PLANNING COMMISSION

Tuesday, December 10, 2024 at 6:00 PM
HYBRID: Council Chambers & Zoom (details below)

**CITY OF ST. HELENS PLANNING DEPARTMENT
STAFF REPORT**

DATE: December 2, 2024
TO: Planning Commission
FROM: Jacob A. Graichen, AICP, City Planner

SEGMENT 4.2: GABLE ROAD

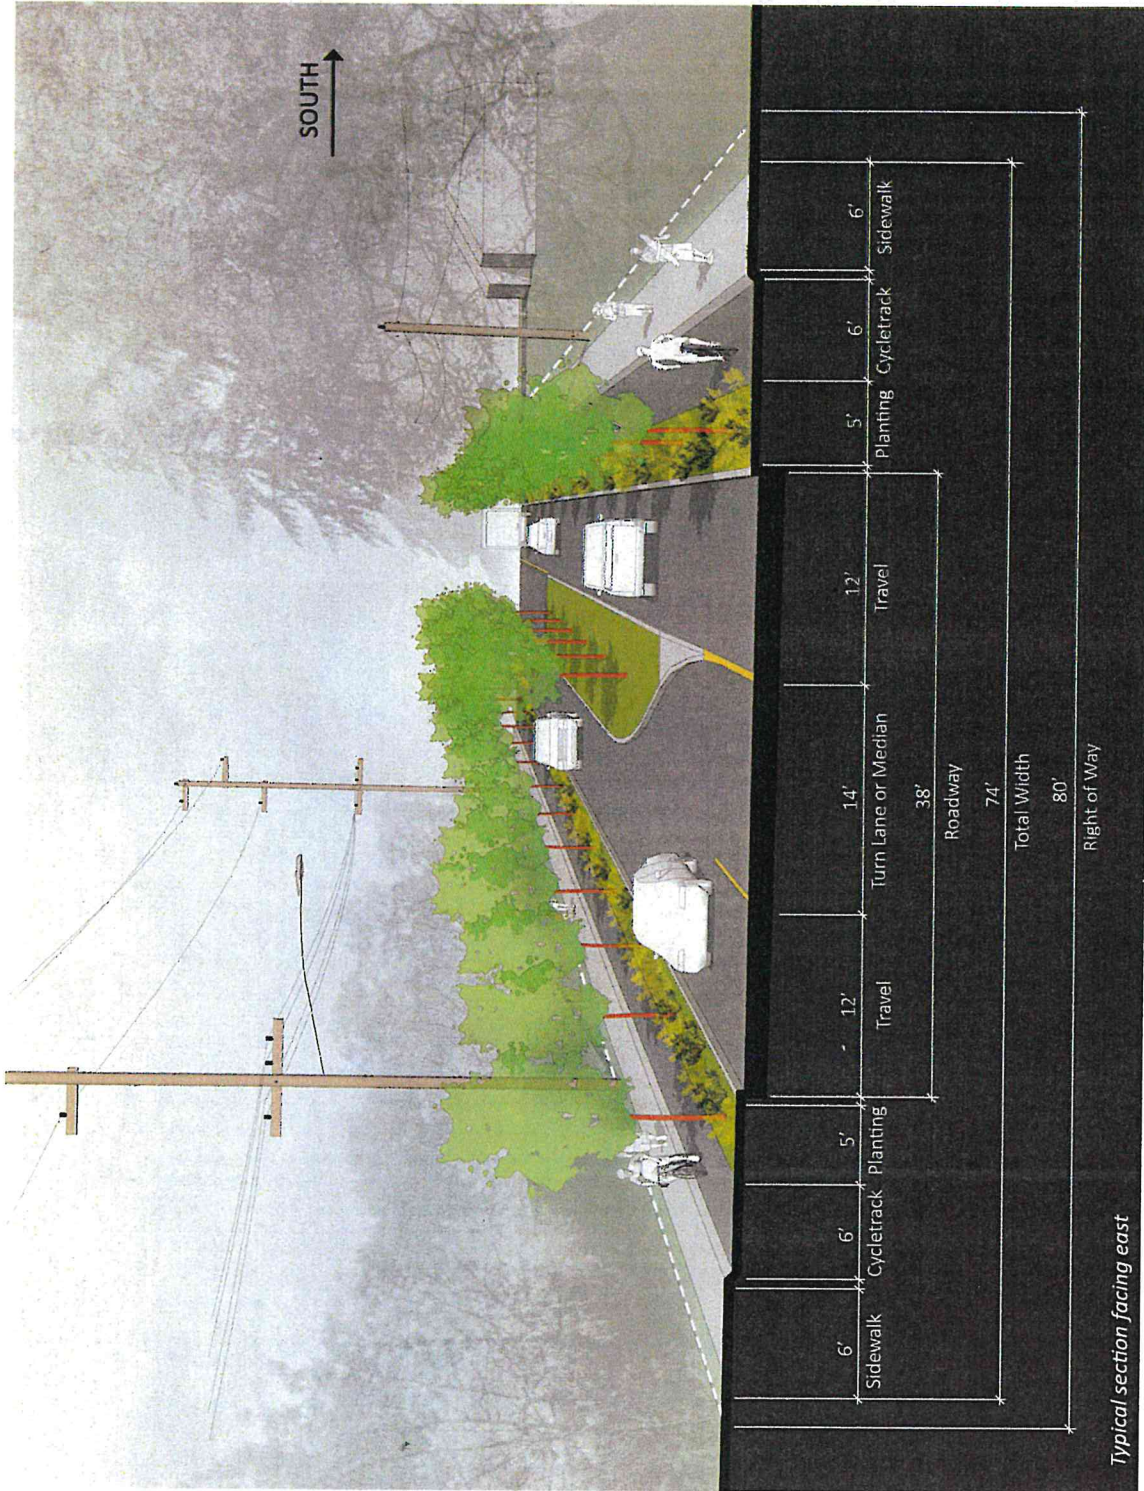
The Riverfront Connector Plan calls for a 14’ wide turn lane or median on Gable Road and how this applies for this proposal has been an discussion point. After receiving comments and testimony on the matter, city staff supports the entire frontage be a 2-way left hand turn lane at this time, for this proposal. See attached Recommended Street Section 4.2 from the 2019 Riverfront Connector Plan and Exhibit “Evaluation of accesses on north side of Gable Road.”

CCMH CAMPUS - PHASE 1 & 2 Building
NOVEMBER 6, 2024
Lot # 4109-BB-00300

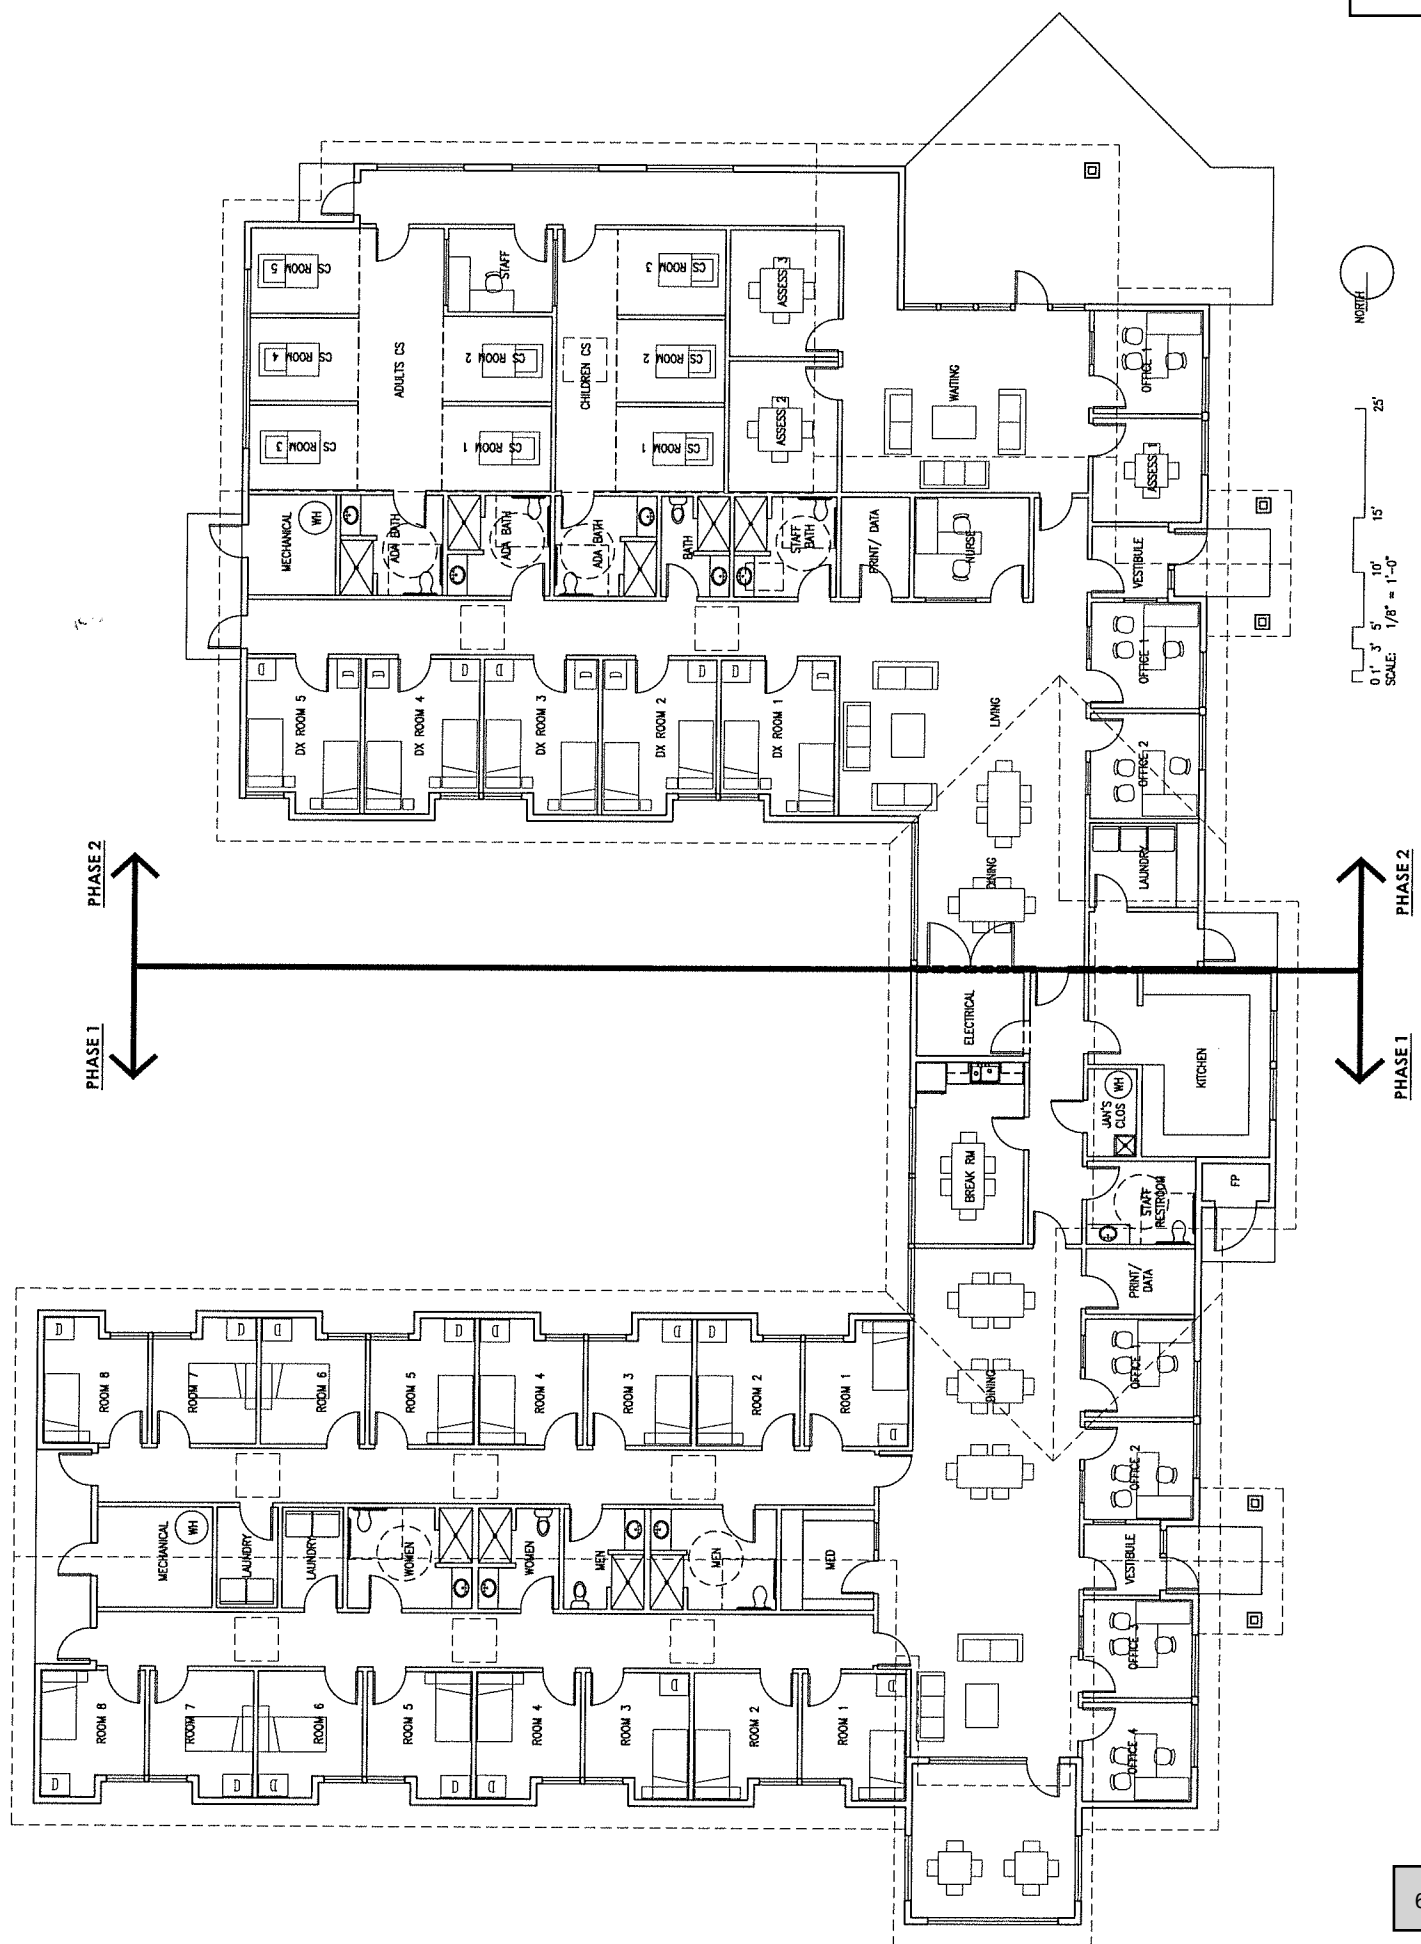
City staff notes that the plan indicating existing parking here is incorrect and should be labeled as proposed parking.

There appears to be some discrepancy between existing spaces identified on the plans and those actually marked. Spaces that are not designated shall not be included on the plans and count towards the final parking county unless they are proposed to be marked and do not conflict with past approvals. But this number of spaces is not anticipated to reduce the total amount below the minimum required.

Left: Photo taken September 27, 2024 of the modular buildings south of the proposed building. Parking spaces as striped (or not striped such as the parallel spaces) conflict with the plans provided. This conflict continued on updated plans received November 6, 2024. Existing and proposed spaces need to be properly identified. The parallel spaces in front of Building H are not marked and if intended to be should be identified as *proposed*. Also, there are three marked spaces in front of Building B whose length is perpendicular to the front of the building as opposed to being five existing spaces parallel with the front of the building as indicated on the plans.

- (1) Three striped spaces including an accessible space in front of Building N are not existing parking spaces in this gravel area and this conflicts with the existing conditions plan sheet C0.50.

- (2) Two parallel spaces in front of Building H are not existing parking spaces. There is no evidence such marking existed. These are not identified on the existing conditions plan sheet C0.50.

- (3) There are three marked spaces in front of Building B. The site plan incorrectly identifies five existing spaces contrary to actual existing conditions and existing conditions plan sheet C0.50.

CONTENTS:
 PHASE 1 & 2
 SITE PLAN

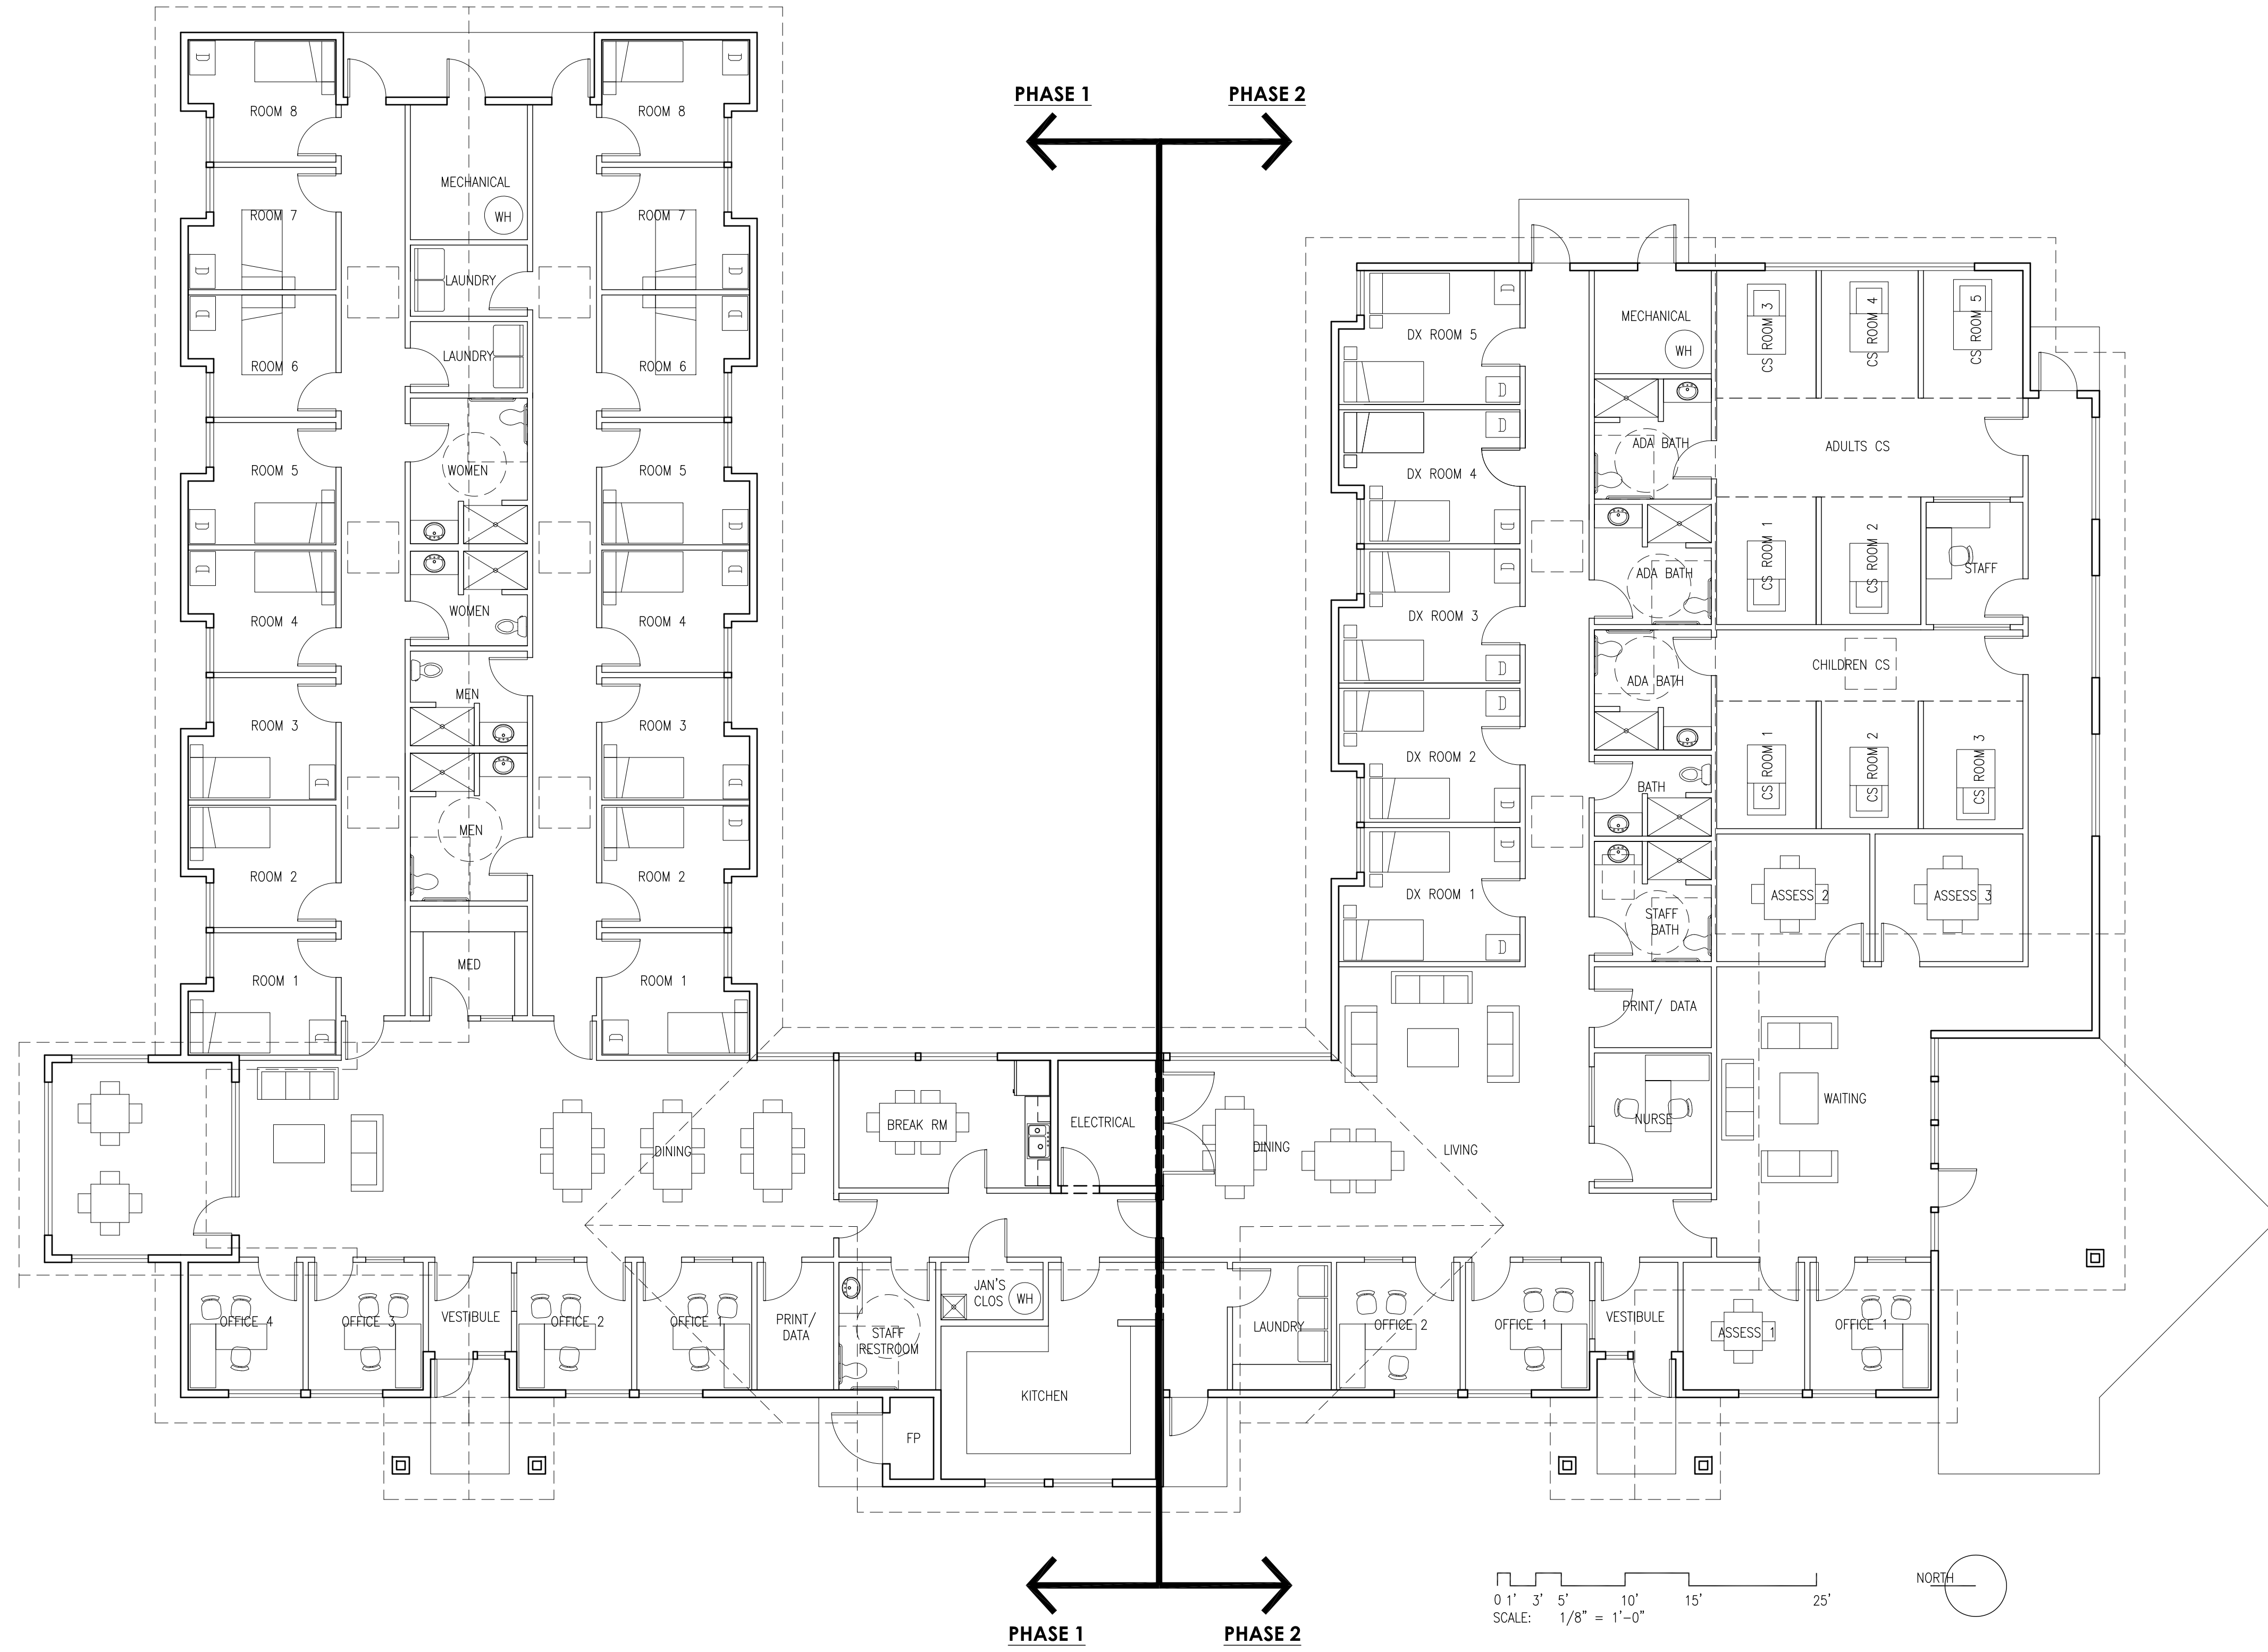
This is shown on the existing conditions but is inconsistent on the plans (e.g., absent on sheet SP-1). This detail will be required on all final plans.

As part of the Site Design Review we propose that the planning commission defer the center landscape islands until development on the north side of Gable Road is established. (Per drawings SP-1) Constructing the center medians without turn pockets (other than for CCMH and McNulty Way) appears to be contradictory to the language in the Riverfront Connector Plan that requires the anticipation of future development..

Our architectural site plan (see drawing SP-1) indicates a “striped median” rather than a landscape island, deferring the construction of the center medians until the properties to the north develop and locations of turn pockets can be determined.
